THE BLUFFS AT CYPRESS CREEK **SUBDIVISION, PHASE ONE**

APPLICATION NUMBER 1 DATE May 21, 2009

REQUEST Subdivision

DETAIL SITE PLAN

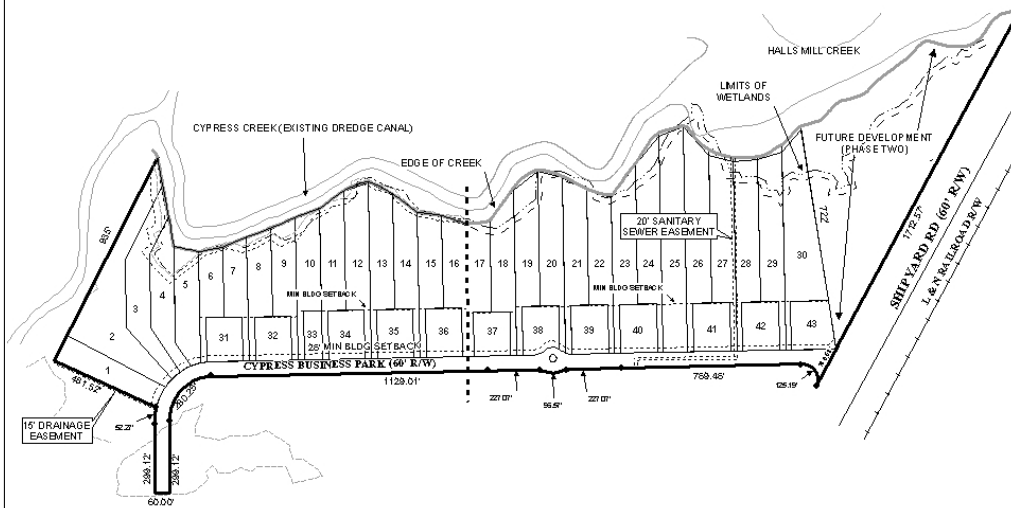
The applicant should revise the 25-foot minimum building setback to illustrate the 25-foot within the lots that are flag-shaped.

The applicant should be aware that flag-pole shaped lots such as several of the proposed lots are unconventional in design; however, as the site is located along a waterway, and in an area of heavy commercial zoning this type of lot design is often used in industrial developments; therefore, the waiver of Section V.D.3. would be required.

As a means of access management, the placement of a note on the Final Plat stating that lots 1-6, 11, 24-26 and 31-43 are limited to one curb-cut, and lots 7 & 8, 9 & 10, 12 & 13, 14 & 15, 16 & 17, 18 & 19, 20 & 21, 22 & 23, 27 & 28 and 29 & 30 are limited to a shared curb-cut along their common interior lot lines, with the size, design and location to be approved by Traffic Engineering and conform to ASHTO standards.

Detention/retention or common areas are depicted on the preliminary plat; therefore, a note should be placed on the Final Plat stating maintenance of these areas will be the responsibility of the property owners.

It should be noted that the above mentioned parcels could be included in this subdivision (as one lot) by providing access (between lots 1 and 2) to a public street as required by the Subdivision Regulations Sections V.D.1 and V.D.4., and creating one more flag lot.

- 1) recoding of the deed providing real property access/frontage to the land locked parcel simultaneously with the recording of the final plat;
- 2) the revision of the 25-foot minimum building setback to reflect 25-foot within the actual buildable area;

- 3) the placement of a note on the Final Plat stating that lots 1-6, 11, 24-26 and 31-43 are limited to one curb-cut, and lots 7 & 8, 9 & 10, 12 & 13, 14 & 15, 16 & 17, 18 & 19, 20 & 21, 22 & 23, 27 & 28 and 29 & 30 are limited to a shared curb-cut along their common interior lot lines, with the size, design and location to be approved by Traffic Engineering and conform to ASHTO standards;

- 8) labeling of all lots with the size in square feet, or placement of a table on the plat with the same information; and
- 9) placement of a note on the plat stating that maintenance of the detention and common areas is the responsibility of the subdivision's property owners.
